July 6, 2016

**PASS CHRISTIAN SITE DEMOLITION AND SITE WORK (REBID)
DEPARTMENT OF MARINE RESOURCES
BILOXI, MISSISSIPPI**

00.903 ADDENDUM NO 3.

SHEET
H1.0R
OF SHEETS

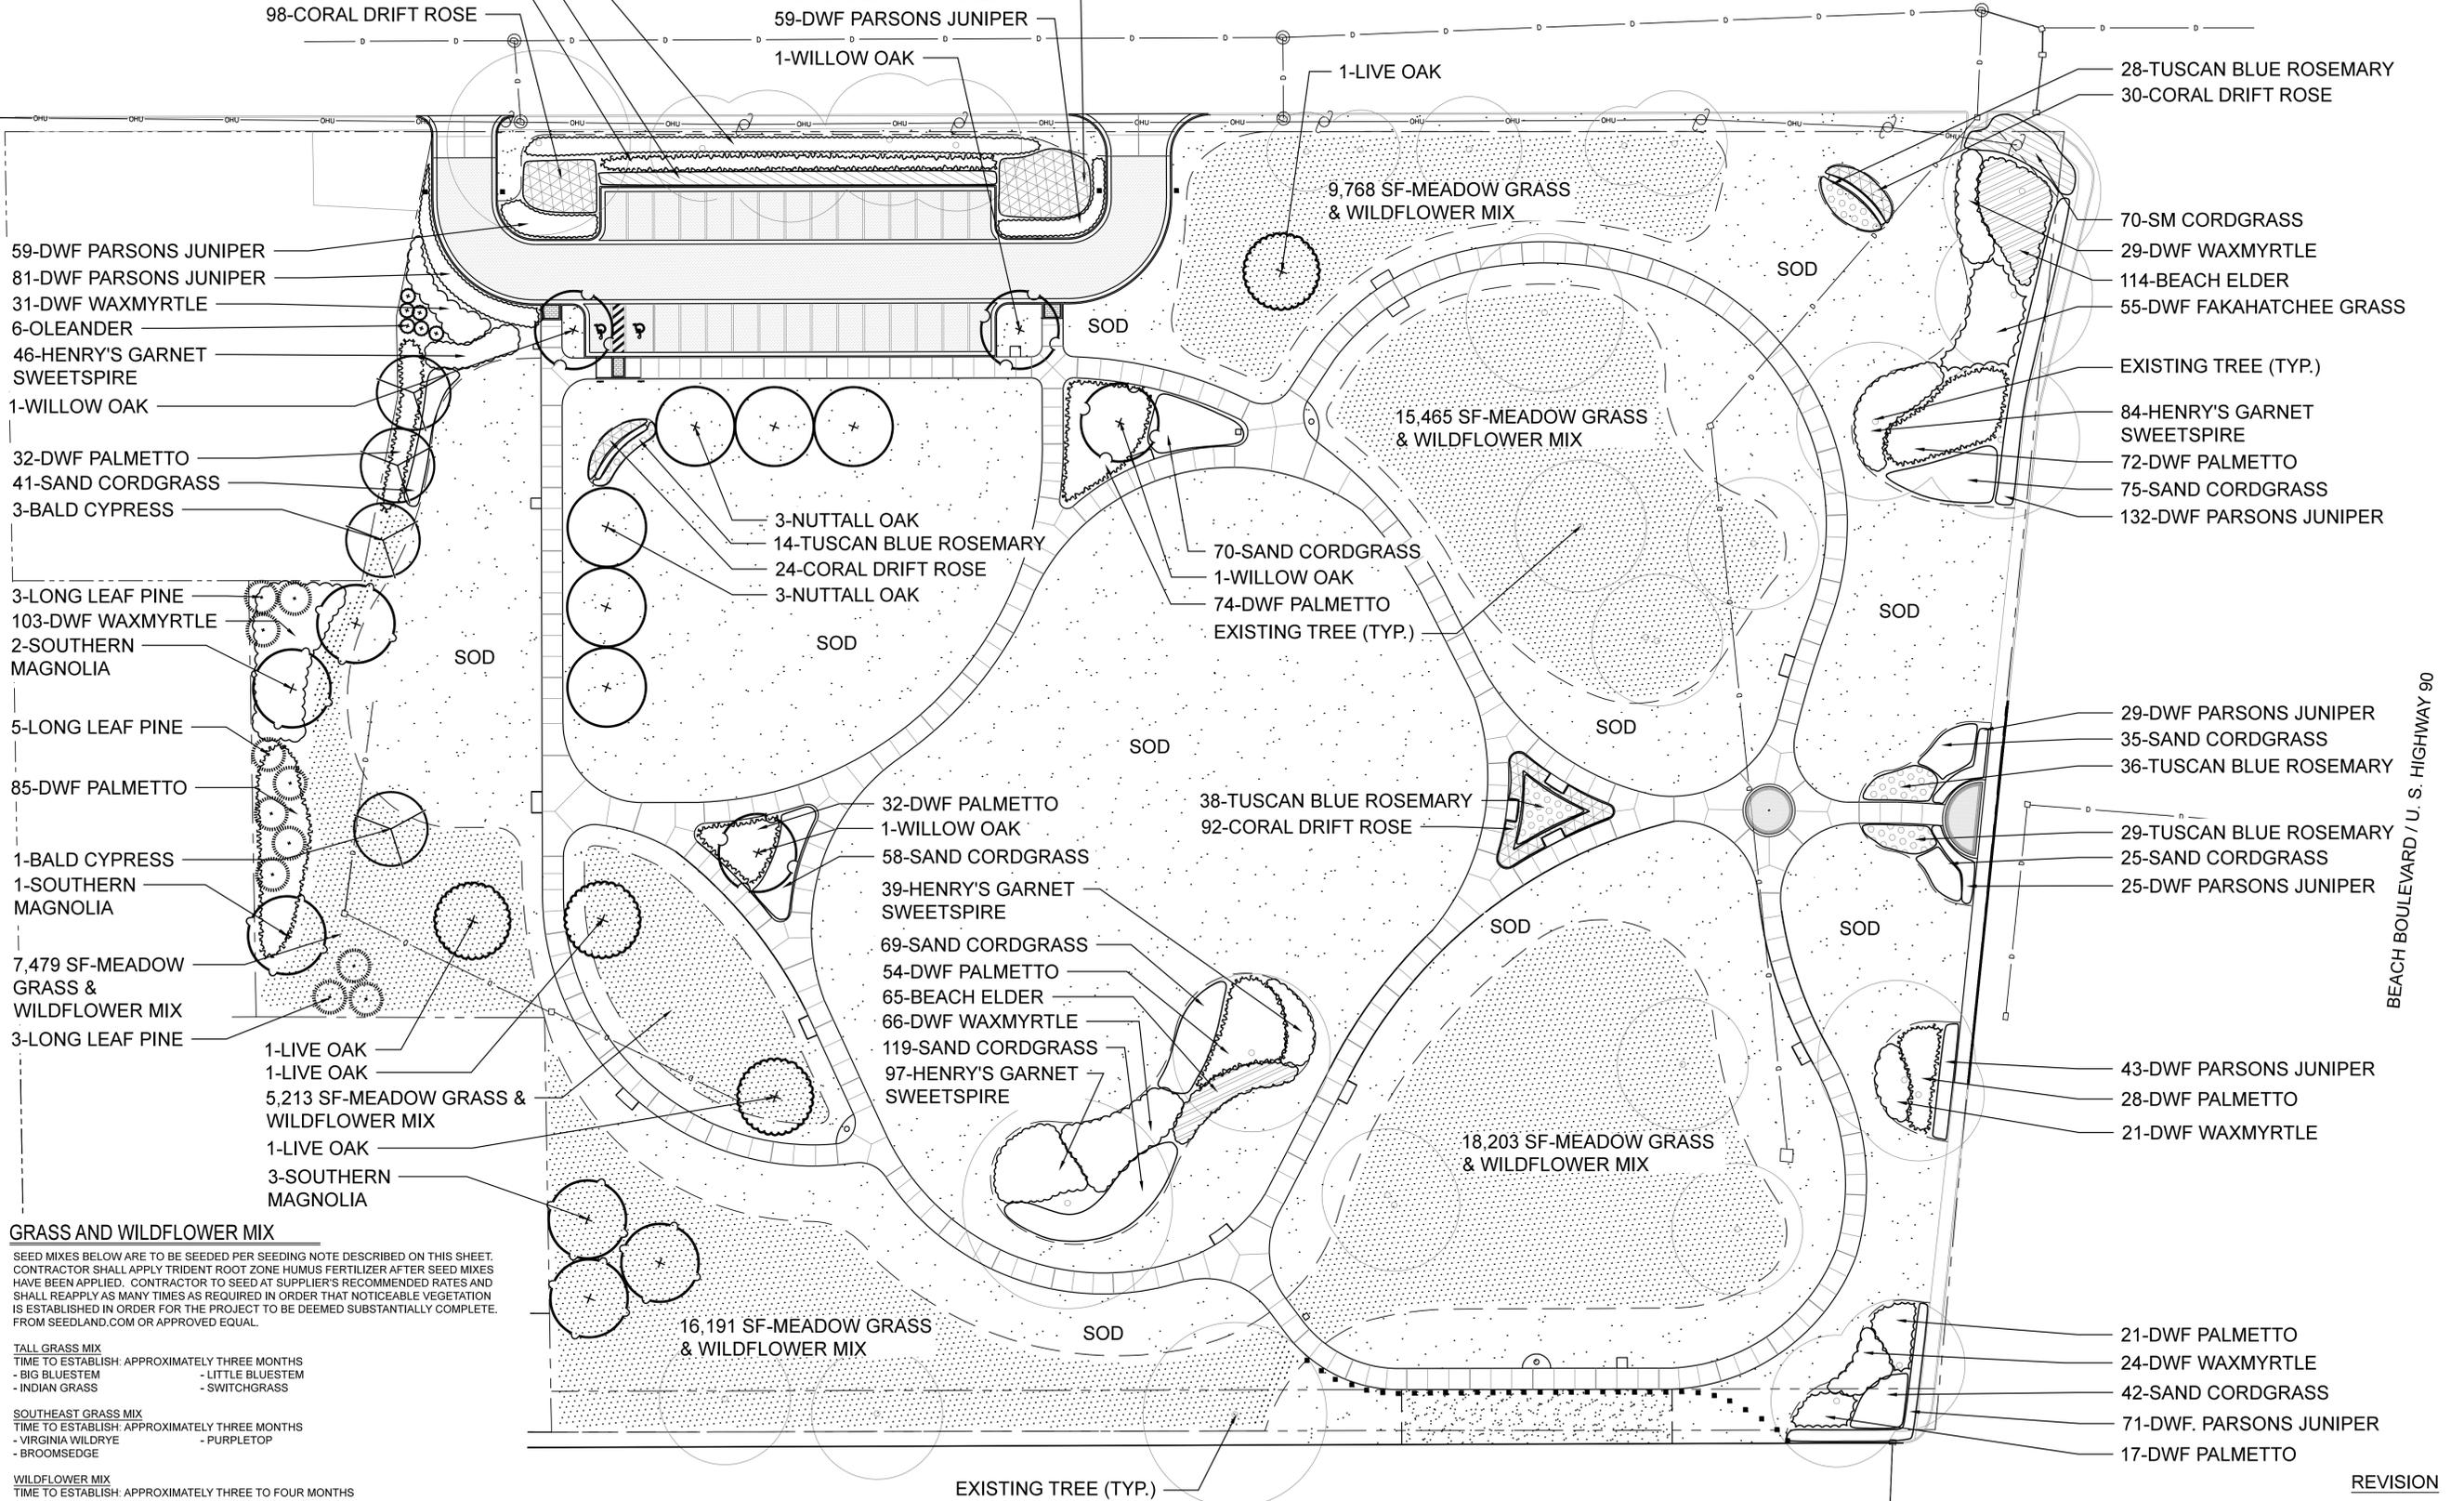
3. Sheet TP1.0 TREE PROTECTION PLAN: DELETE this sheet in its entirety and replace with Sheet TP1.0R TREE PROTECTION PLAN (attached).
4. Sheet H1.0 HARDSCAPE PLAN: DELETE this sheet in its entirety and replace with Sheet H1.0R HARDSCAPE PLAN (attached).

5. Sheet H1.0R HARDSCAPE PLAN:
 - a. Contractor shall provide four 11x17 educational signs. Placement of 4th sign shall be determined by Landscape Architect in field. See detail 2/H1.4 for educational signage requirements. All educational signage shall be included in the base bid.

L2.0R

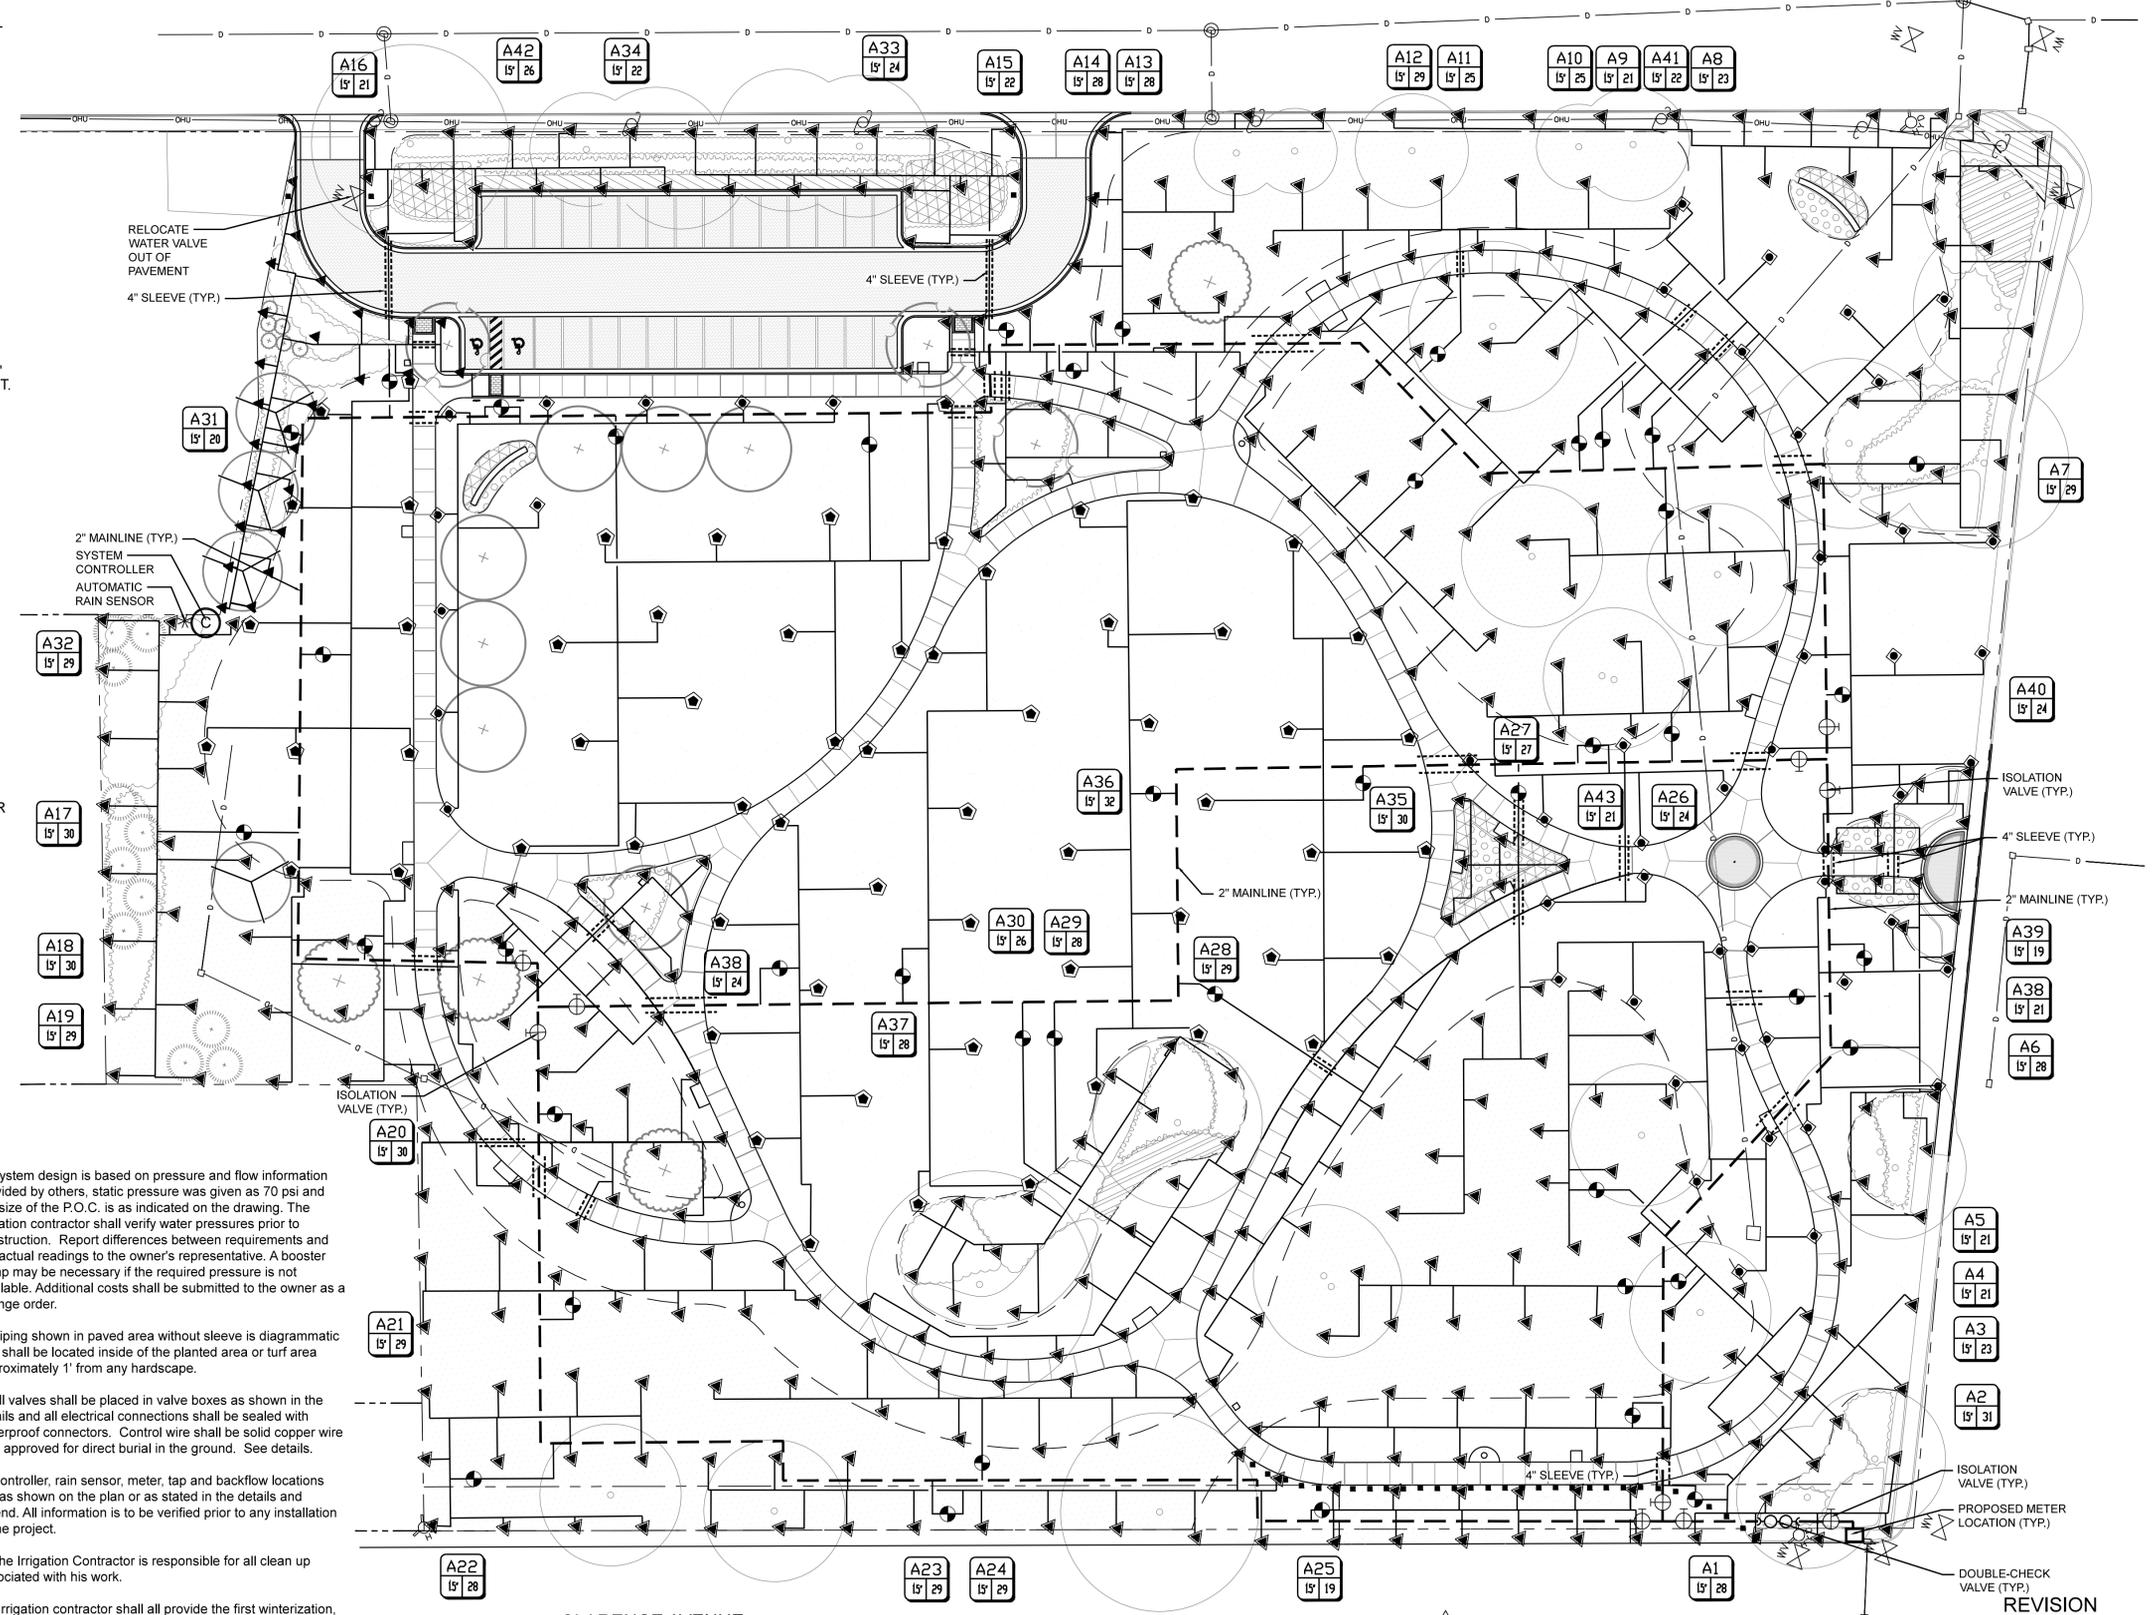
9. Sheet L2.0 IRRIGATION PLAN: DELETE this sheet in its entirety and replace with Sheet L2.0R IRRIGATION PLAN (attached).
10. Sheet U1.0 UTILITIES PLAN: DELETE this sheet in its entirety and replace with Sheet U1.0R UTILITIES PLAN (attached).

3. On plan page L2.0 it calls for the mainline to be 1.00" Class 200 Pipe (in the legend) and is labeled on the plan as 2.00". Please clarify.
- a. **The irrigation mainline shall be a 2" mainline as noted on the plan.**

4. Irrigation Plan L2.0 calls for the mainline to be Class 200 Pipe while the irrigation specifications 02810 page 5 of 7 calls for the mainline to be SCH40 pipe. Please clarify.

- a. **Correct. The contractor shall install a tree irrigation bubbler at the base of all newly planted trees.**
6. It appears that the scale bar in the landscape and irrigation drawings is incorrect. Please verify.

- a. **The irrigation mainline can be Class 200 BE or Schedule 40.**
5. Please verify that tree irrigation bubblers are to be provided for all new trees on the plans.

- a. **See Section CHANGES TO THE DRAWINGS, this addendum, for reissued sheets.**

P100010

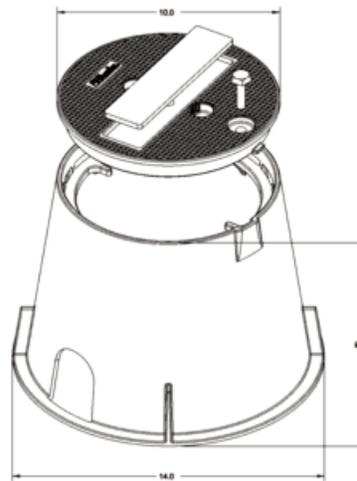
- a. Electrical Legend - REVISE per attached ESK-1
12. Sheet E2.1 ELECTRICAL DETAILS, Detail 5-Junction Box Detail at Trees:
 - a. REVISE box size to be 10 inches, round
 - b. See attached cut sheet for round, HDPE constructed boxes. Provide and install boxes as manufactured by Charles Industries, Ltd or equal. Boxes shall be equal to Charles Industries #P100010 with green lid and body and ELECTRIC stamped on lid.
